Downtown Code Design Review Committee

Meeting Minutes

1) Voorhees Residential Development – Tower 2

2) Voorhees Residential Development – Tower 1

Figure 6: Modification Request Diagram

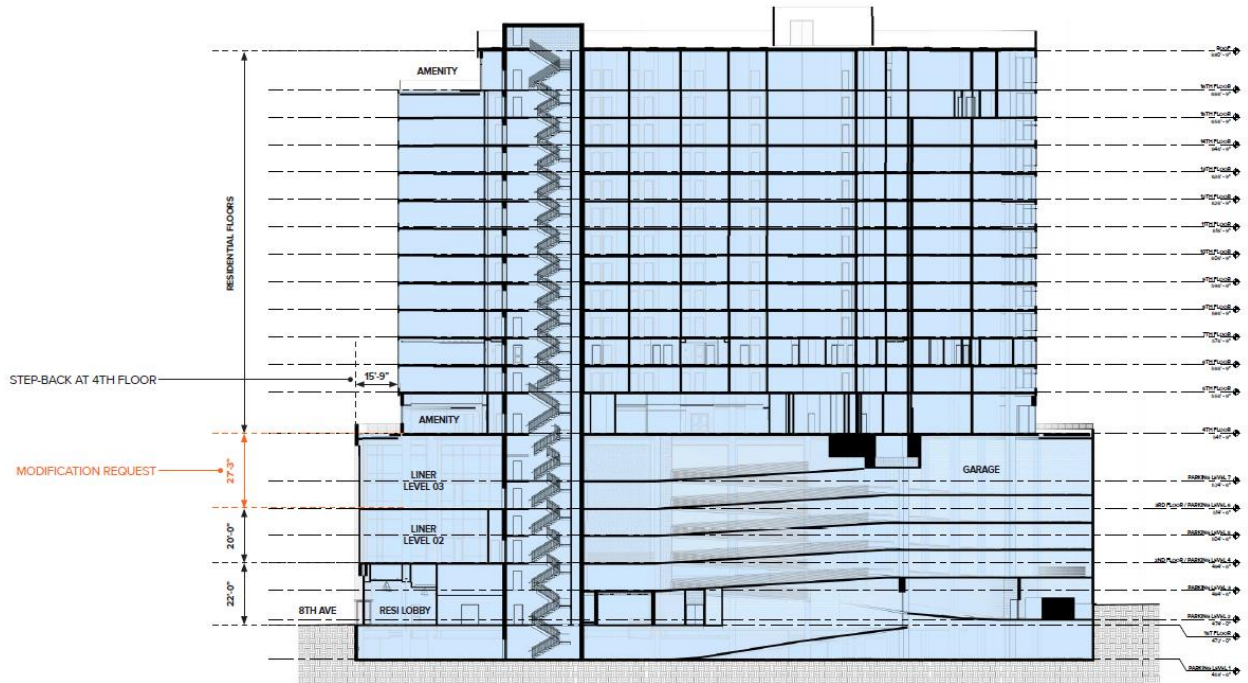
The DTC requires the maximum height of an individual story above the second story, to not exceed 18 feet. The intent of this is to establish reasonable floor-to-floor heights, while preserving proportionality. Without reasonable limits to the height of each floor, unpredictable outcomes could occur that are contrary to the intent of height limitations. In this case, the third floor is being proposed with a height of 27'-3" for the liner unit to fully screen the parking garage.

Staff finds that the proposed height of the third floor is not enough to negatively affect the proportions of the building. Achieving an upper-level garage liner is a worthy trade-off for the increased height of the floor. In addition, there have been reasonable efforts made on the exterior of the building to visually break up the height of this floor and match it with the other liner unit floors.

Staff recommends approval of the requested modification with the following conditions and deferral without all conditions:

1. All bonus height actions identified in this application, including those that require a deed or restrictive covenant, must be approved prior to building permit approval.

2. The applicant shall coordinate with Metro Public Works on the proposed 8th Avenue South mid-block crosswalk.
3. All overhead lines along the master plan site's 8th Avenue South frontage shall be buried.

4. Both the Historic Antiques Mall and the Historic Voorhees Building must be designated as Historic Landmark Zoning Overlays prior to building permit approval.

5. Approval of this modification shall be reconsidered by the DTC Design Review Committee if either the Historic Antiques Mall or the Historic Voorhees Building are not able to achieve or maintain Historic Landmark Overlay status.
